DEPARTMENT OF THE AIR FORCE  
HEADQUARTERS 377TH AIR BASE WING (AFMC)

Per your 7 March 2011 request, Kirtland AFB is submitting this request to relocate four ground water monitoring (GWM) wells as previously described in your 6 August 2010 letter. In support of this request, I am including justification for each relocation, as well as, aerial photographs showing both the current well site locations and our proposed relocations.

# ATTACHMENT 1

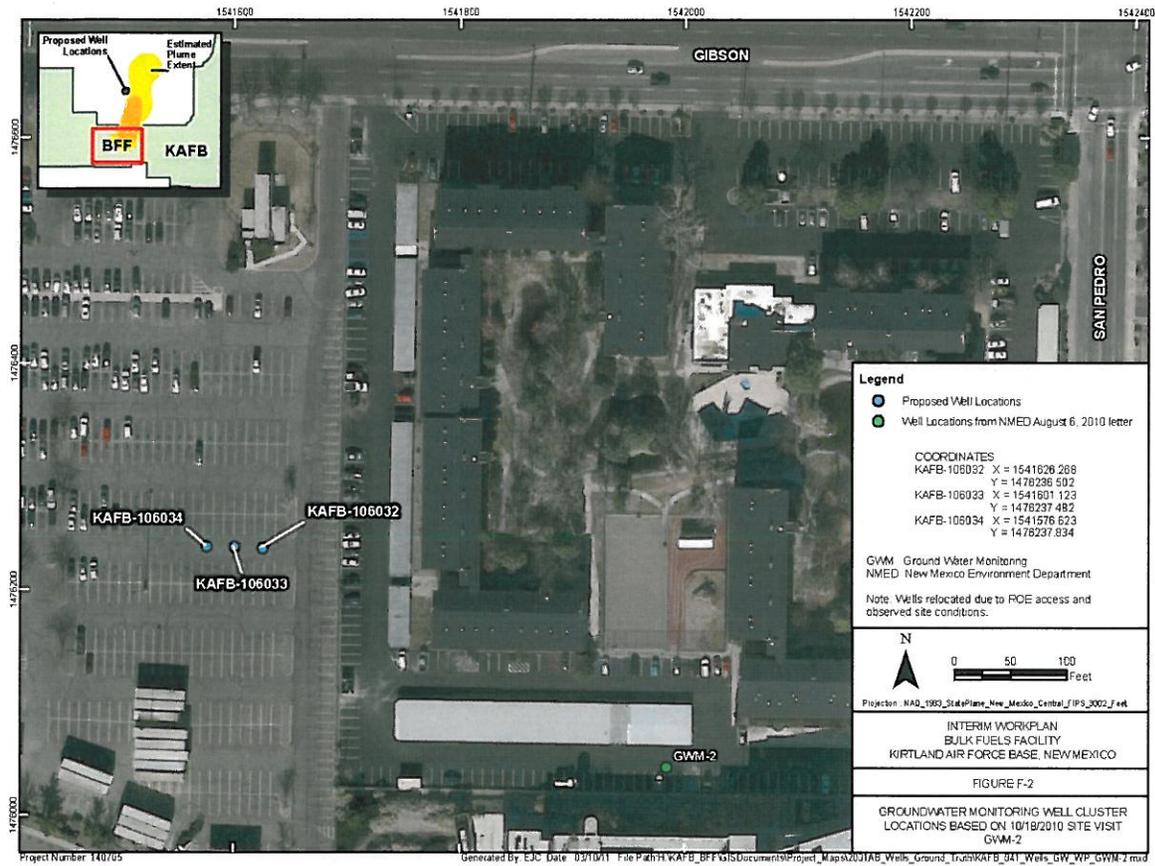
- GWM-1 was moved to the north and east of the current well site location due to right-of-entry issues and safety concerns. The required well site is located in a privately-owned parking lot, just north of Gibson. In order to move the well site (less than 100 feet) to a City of Albuquerque right-of-way, the site would be on Gibson, which poses logistical and safety concerns for drilling and sampling the wells. Accordingly, we are requesting that the well site be relocated to an alternate location on the next accessible City of Albuquerque right-of-way, San Pedro Drive SE. This proposed well site maintains a data point along the northern and western edge of the suspected dissolved-phase plume. (attachment–KAFB\_029\_Wells\_GW\_WP\_GWM-1)

# ATTACHMENT 2

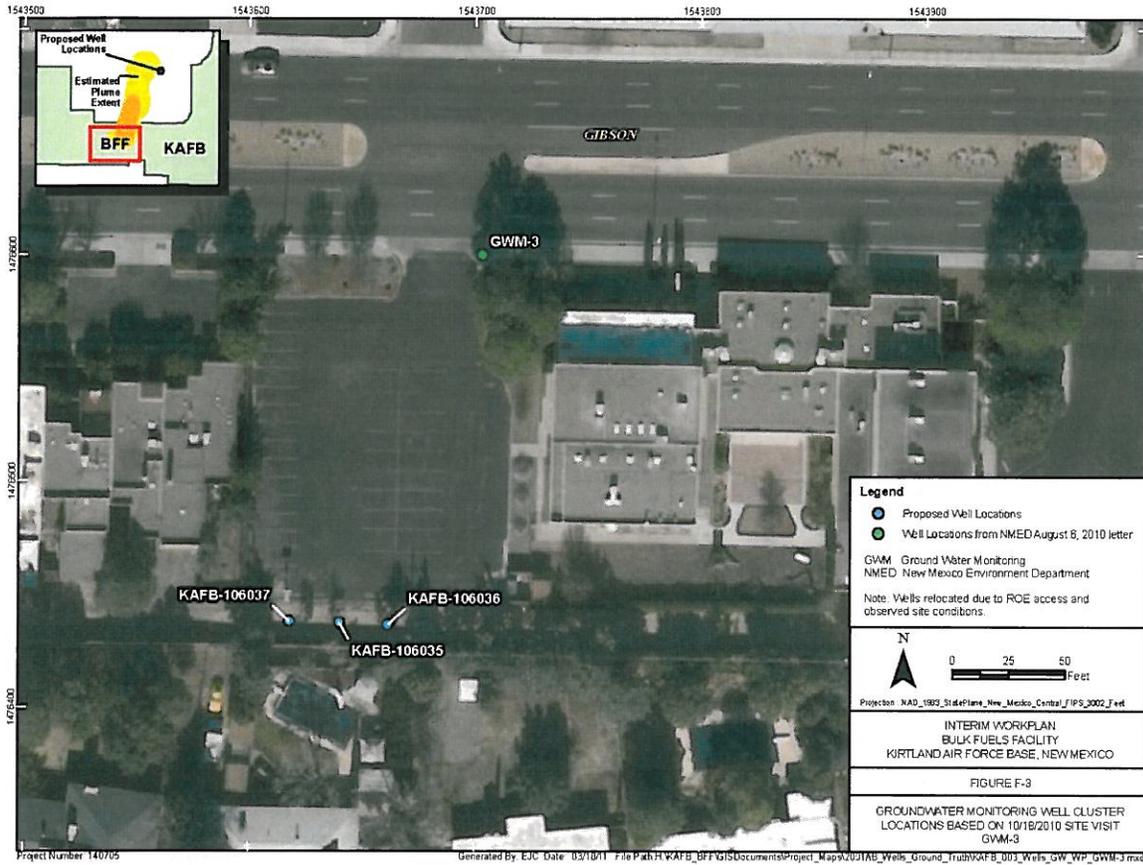
- Well site GWM-2 is currently located on private property. During the site visit, an attempt was made to relocate this well site to City of Albuquerque property due to right-of-entry access issues. No suitable relocation site was identified and the well site must remain on private property. However, GWM-2 must be moved from the original location due to safety

and logistical concerns. The original well site is located in the back parking lot of a privately-owned apartment complex. Drilling at this site would block emergency access to the apartment complex. Kirtland AFB is currently evaluating whether or not GWM-2 can be moved due east to the open parking lot of the Gibson Medical Center. The land owner/tenant has been contacted and a request has been submitted for their review. Until approval is granted, drilling at this site will be delayed. The final relocation site will be presented to the NMED for approval. (attachment 2 – KAFB\_041\_Wells\_GW\_WP\_GWM-2)

ATTACHMENT 3

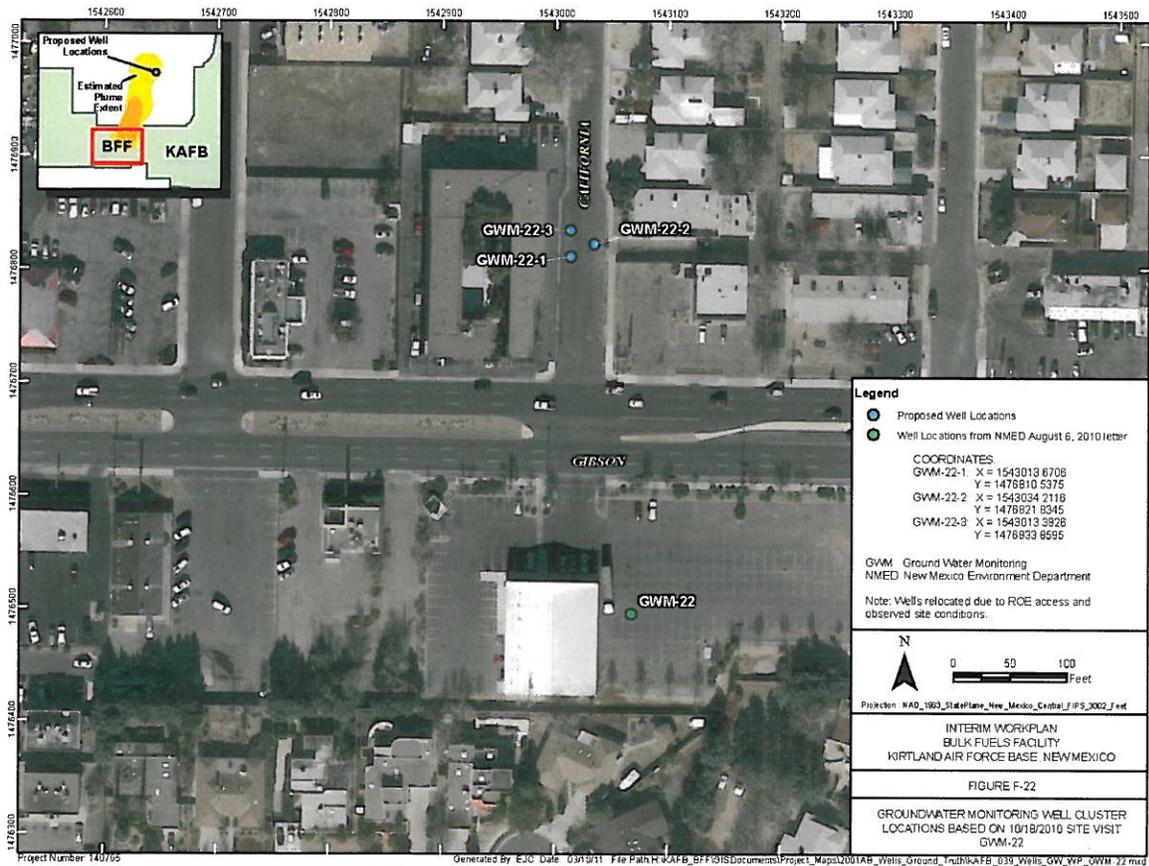
- The GWM-3 well site is located on Gibson Ave. It presents significant safety and logistical concerns for drilling and sampling. We request GWM-3 be relocated approximately 150 ft due south to a City of Albuquerque right-of-way. The relocated well site preserves the data point near the eastern edge of the dissolved-phase plume boundary and is on property that can be accessed. (attachment 3 – KAFB\_003\_Wells\_GW\_WP\_GWM-3)
